Item Name: Dual High Back Seat Installation

DART SERVICE INSTRUCTION

TO AMEND INSTALLATION INSTRUCTIONS IIN-D350-689 REV. B AND INSTRUCTIONS FOR CONTINUED AIRWORTHINESS ICA-D350-689 REV. 1

REF. TCCA STC: SH02-33
REF. FAA STC: SR01620NY
REF. EASA STC: EASA.IM.R.S.01453
REF. TCA STC: 2005S03-09

FIGURE 1: UPDATES TO CROSS SECTIONS F-F AND M-M
 With reference to Figures 5 and 7 of IIN-D350-689
 (Figures 25-5 and 25-7 of ICA-D350-689)

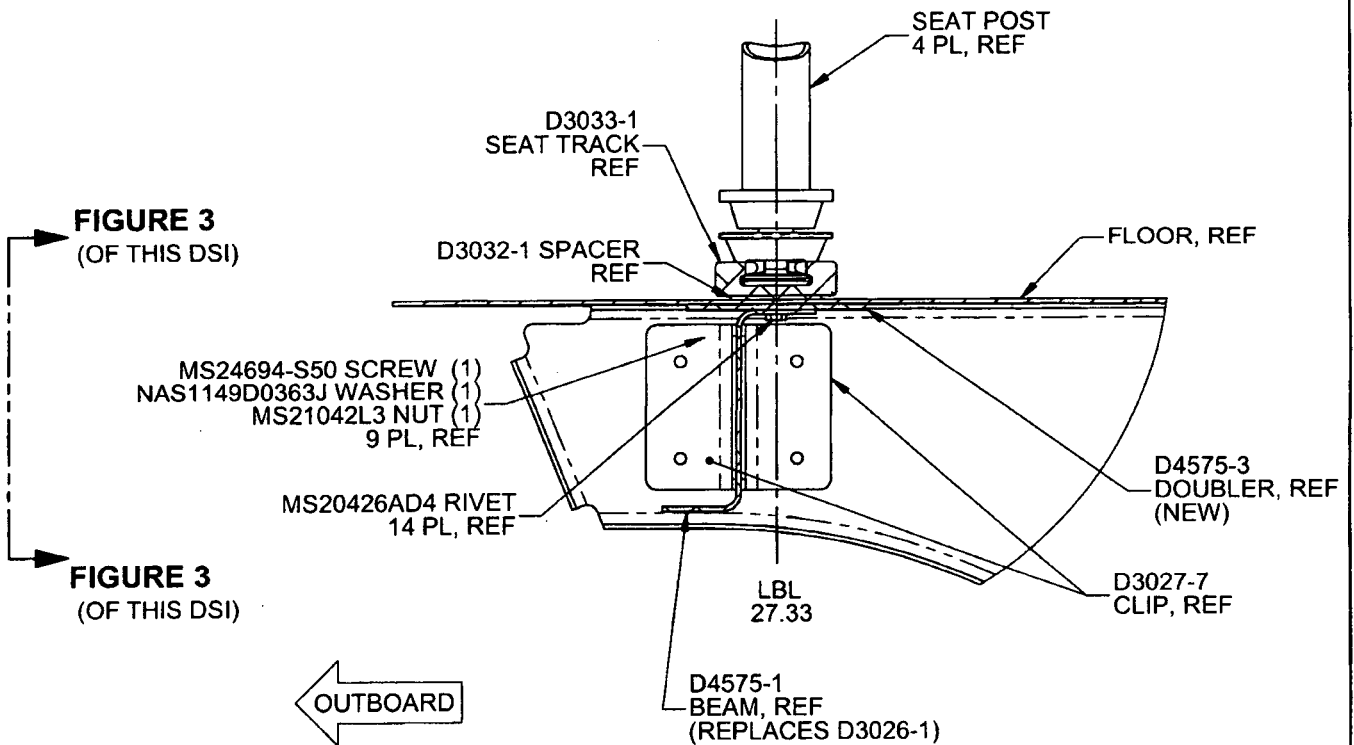
If there is an existing stringer at LBL 27.33, it will need to be removed from that location. Locate D4575-1 Beam, D4575-3 Doubler, and D3032-1 Spacer as shown in Figure 1 of this Service Instruction. Transfer drill existing holes from the aircraft floor to the D4575-1 Beam, D4575-3 Doubler, and D3032-1 Spacer. Ensure 1.0" to 1.5" rivet pitch and add additional holes if required. If there is no existing stringer, locate D4575-1 Beam, D4575-3 Doubler, and D3032-1 Spacer as shown in Figure 1 of this Service Instruction and drill Ø0.128" holes on a 1.0" to 1.5" pitch.

If there is an existing stringer at LBL 27.33, it will need to be removed from that location. Locate D4575-1 Beam and D4575-3 Doubler as shown in Figure 2 of this Service Instruction. Transfer drill existing holes from the aircraft floor to the D4575-1 Beam and D4575-3 Doubler. Ensure 1.0" to 1.5" rivet pitch and add additional holes if required. If there is no existing stringer, locate D4575-1 Beam and D4575-3 Doubler as shown in Figure 1 of this Service Instruction and drill Ø0.128" holes on a 1.0" to 1.5" pitch.

CROSS SECTION VIEW F-F/M-M: From Figures 5 and 7 (IIN-D350-689)
CROSS SECTION VIEW F-F/M-M: From Figures 25-5 and 25-7 (ICA-D350-689)

FIGURE 3: RELIEFS ON D4575-1/-3
(ONLY D4575-1/-3 SHOWN FOR CLARITY)
VIEW LOOKING INBOARD

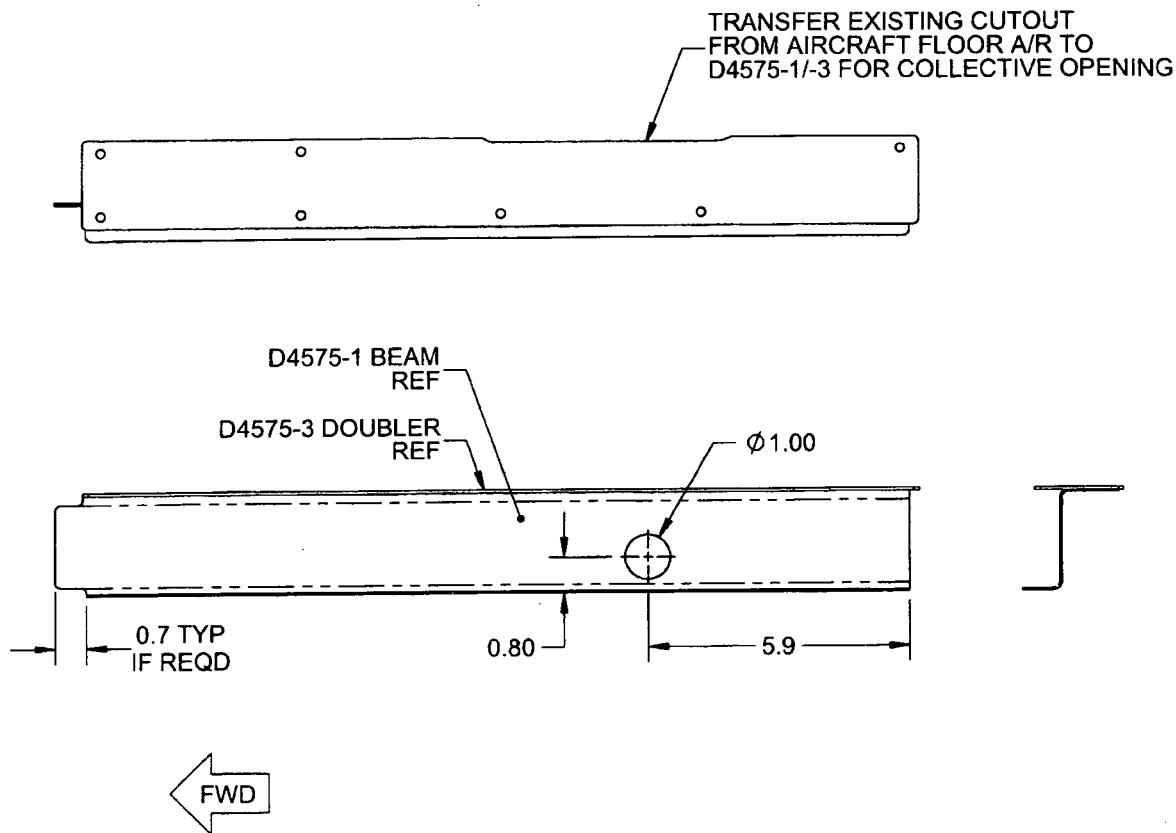
Note: Drill a Ø1.00" (Ø25.4 mm) hole in the D4575-1 Beam to clear extension tube of collective and cutout as required for clearance of collective opening and fwd bulkhead as shown in Figure 3 of this Service Instruction.

Note: Drill a Ø1.00" (Ø25.4 mm) hole in the D4575-1 Beam to clear extension tube of collective and cutout as required for clearance of collective opening and fwd bulkhead as shown in Figure 3 of this Service Instruction.
